Modeling Hourly Diurnal Emissions and Interrupted Diurnal Emissions Based on Real-Time Diurnal Data

M6.EVP.002

This report was originally released (as a draft) in May 1998, and then revised (and re-released) in July 1999. This current version is the final revision of the July 1999 draft (of M6.EVP.002). This final revision incorporates suggestions and comments received from stakeholders during the 60-day review period and from peer reviewers.

Figure 4-3

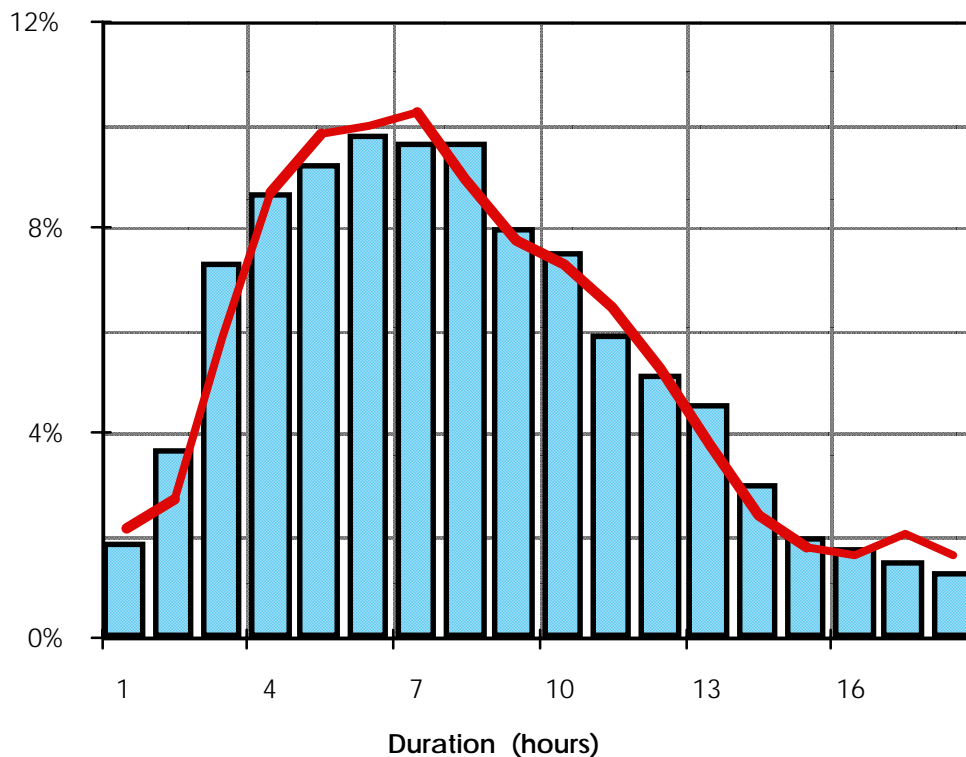
What is meant by "the shape of the hourly diurnal emissions" is not clear, but the phrase is presumed to refer to the shape of a plot of hourly diurnal emissions vs hour considered, as in Figure 4-1 [renamed Figure here as 4-3].

In another instance (see Figure 4-1 [renamed Figure 4-3]), a plot of "actual" vs "predicted" values is presented, this time in the usual way except that the "actual" values are plotted as a bar graph rather than as a scatter plot of points. The width of the bars tricks the eye into believing that the agreement is better than is actually the case. See Appendix II [renamed here as Appendix G-2] of this review document for further detail.

The closest approach to comparing observed and computed values is in Figure 4-1 [*renamed Figure here as 4-3*], in which the computed values for gross liquid leakers are plotted as a solid line. In the usual scatterplot, one would expect the observed values to be plotted as points to show how well the line cuts through the observed data. Instead, a bar graph is used to represent the observed hourly emissions. This bar-graph presentation tends to obscure the relatively large differences between observed and calculated responses.

That is correct. The text has been revised to eliminate that potential ambiguity.

Each bar (in Figure 4-3) represents the total diurnal emissions occurring in each full hour. Therefore, each bar is approximately one hour in width.

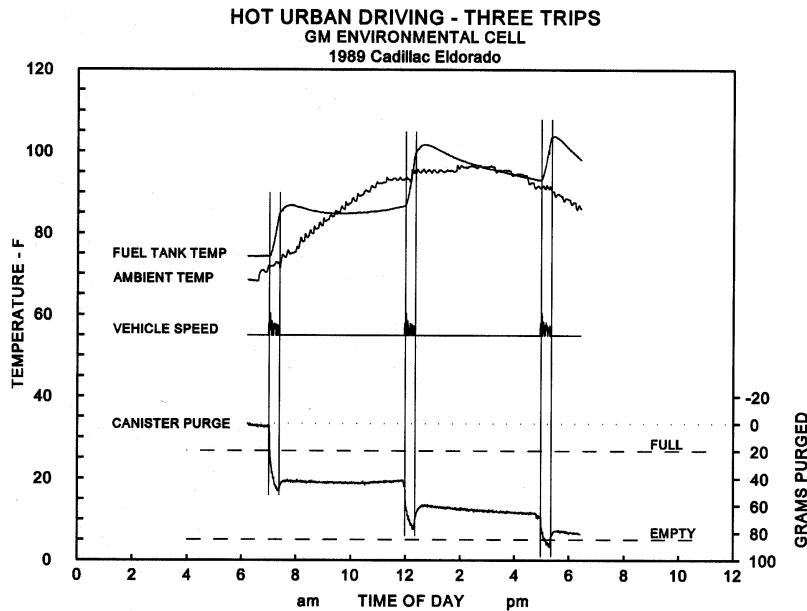
At 5.1, Interrupted Diurnal, A plot previously furnished to the Agency (See below) would help to illustrate the concept. A full set of these plots, and the text that explains them is included later in this report.

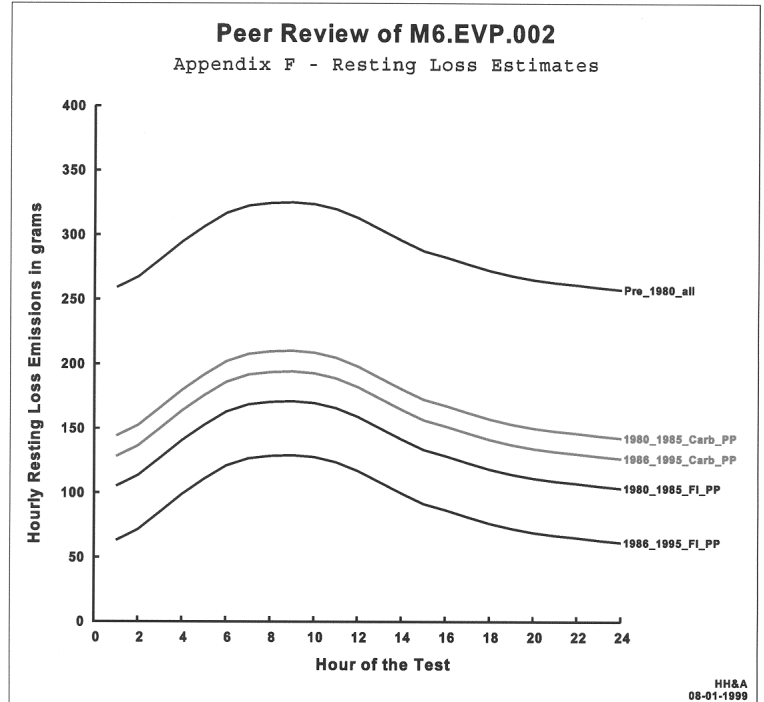
The estimates for hourly resting loss emissions mentioned in Appendix F *[renamed here as Appendix H-1]* appear to follow a simple correlation to the ambient temperature, with an initial value offset to reflect various technologies and conditions. The plot shown below and to the right presents plots of some of the combinations listed in Appendix F *[renamed here as Appendix H-1]*, focusing on the "pass pressure" condition, and the 72 to 96°F diurnal cycle.

If "resting losses" are for the main part, permeation, why not pursue an exponential form of temperature

correction? Is the simple form in Appendix F *[renamed here as Appendix H-1]* appropriate? Why?
